UNITED STATES PATENT AND TRADEMARK OFFICE

APPLICATION NO.	FILING DATE	FIRST NAMED INVENTOR	ATTORNEY DOCKET NO.	CONFIRMATION NO.
10/661,549	09/15/2003	Takayuki Nagata		9048
23364	7590	08/18/2005		
BACON & THOMAS, PLLC			EXAMINER	
625 SLATERS LANE				ZARROLI, MICHAEL C
FOURTH FLOOR			ART UNIT	PAPER NUMBER
ALEXANDRIA, VA 22314				2839

Office Action Summary	Application No.	Applicant(s)
	10/661,549	NAGATA, TAKAYUKI
	Examiner	Art Unit
	Michael C. Zarroli	2839

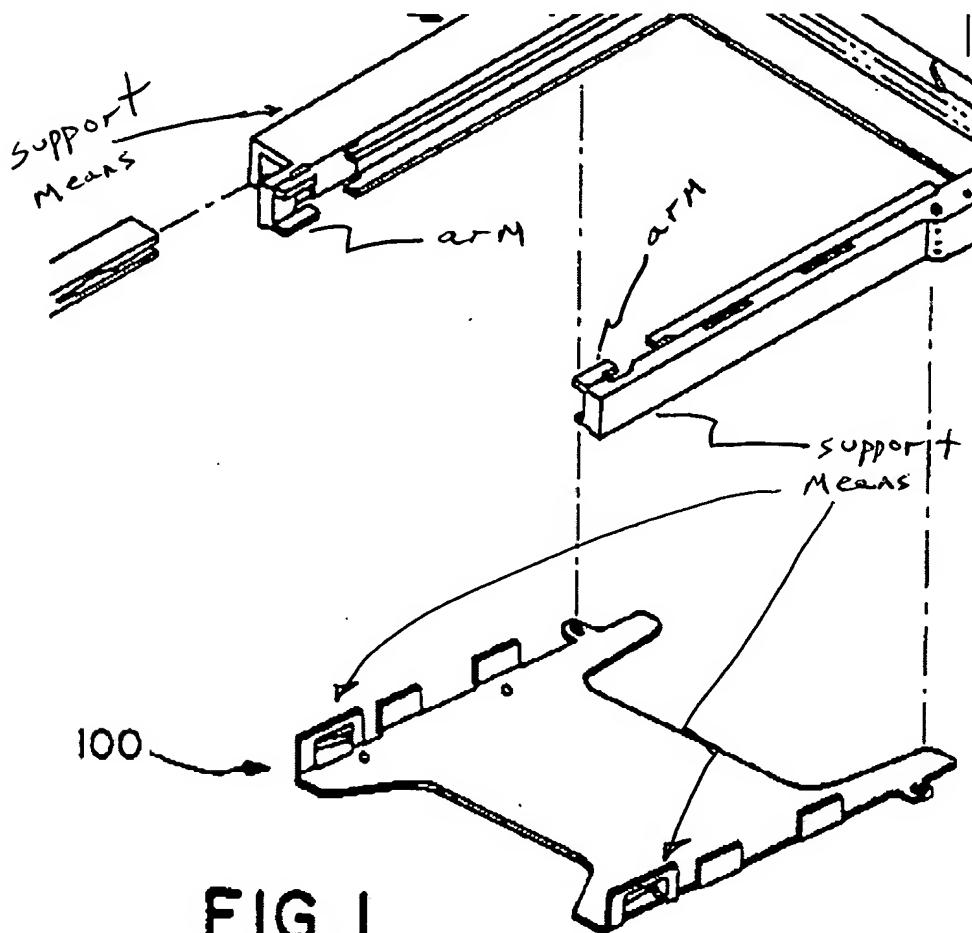
4. Claims 8-10 rejected under 35 U.S.C. 102(b) as being clearly anticipated by McHugh.

McHugh discloses a card connector (title) comprising: a body (12) made of an integral molded product of a synthetic resin (col. 11 lines 10-15), said body including a head portion and a pair of arms (unnumbered fig. 2) which extend outwardly from said head portion (fig. 14A top, fig. 14C right), each arm of said pair of arms including a foremost end portion (e.g. fig. 1 unnumbered, each arm has an end) a plurality of multipolar contacts (120, 126); and a sheet metal frame (100) which extends between said pair of arms (fig. 1), and which cooperates with said body to form a card insertion space (fig. 14A), wherein: said sheet metal frame including arm support means (see figure below) for blocking inward deflections of said foremost end portions said arm support means is configured by a receiving piece (108, 109, 110) which butts against an inward engagement face that is provided in a foremost end portion of one of said arms (fig. 4 between 97 & 99), said arm-supporting means (see fig. below) is extended in a thickness direction (fig. 14D 72 down) of a card C (not shown) which is to be inserted into said card insertion space, and a lateral width W of a insertion slot (fig. 15A

between arms) of said card insertion space is defined by a distance between opposing inward faces of said receiving pieces (fig. below, arrows).

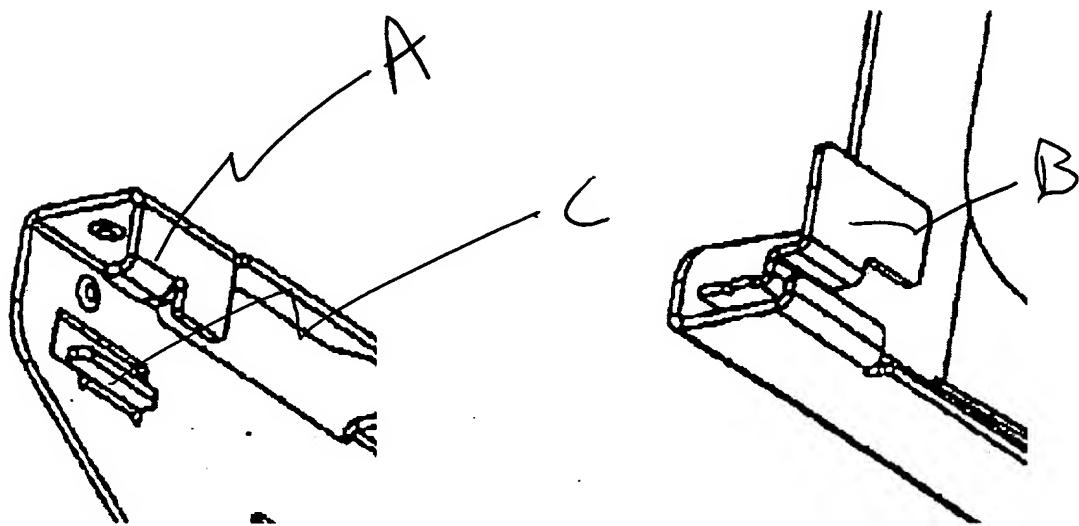
5. Claims 8 and, 13-14 rejected under 35 U.S.C. 102(e) as being clearly anticipated by Chang.

Chang discloses a card connector (title) comprising: a body (2) made of an integral molded product of a synthetic resin said body including a head portion (20), and a pair of arms (22, 24) which extend outwardly from said head portion (fig. 1) each arm of said pair of arms including a foremost end portion (also at 22, 24 in fig. 1) a plurality of multipolar contacts (34); and a sheet metal frame (5) which extends between said pair of arms (fig. 2), and which cooperates with said body to form a card insertion space (200), wherein: said sheet metal frame including arm support means (528, 548) for blocking inward deflections of said foremost end portions (in fig. 3 foremost ends are prevented from deflecting by sheet metal frame arm support means), said arm support means is configured by a receiving piece (528, 522, 542, 548) which butts against an inward engagement face that is provided in a foremost end portion of one of said arms (figures 1 & 3) said arm-supporting means is extended in a thickness direction (fig. 1 at 521 & 541) of a card C (104) which is to be inserted into said card insertion space (fig. 10), and a lateral width W of a insertion slot (fig. 2 between arms) of said card insertion space is defined by a distance between opposing inward faces of said receiving pieces.

Regarding claim 13 Chang discloses that plate-like pieces (521, 541) which overlap outward faces of said pair of arms (fig. 3) to reinforce the arms respectively are formed by bending said frame (fig. 1).

Regarding claim 14 Chang discloses that said frame has a face plate portion (50) which is extended from said head portion of said body to said foremost end portions of said arms (figures 1 & 3), and positions a, b (22, 24) of said foremost end portions of said arms where engagement faces are formed are clamped between said plate-like pieces and said arm supporting means, respectively (fig. 3).
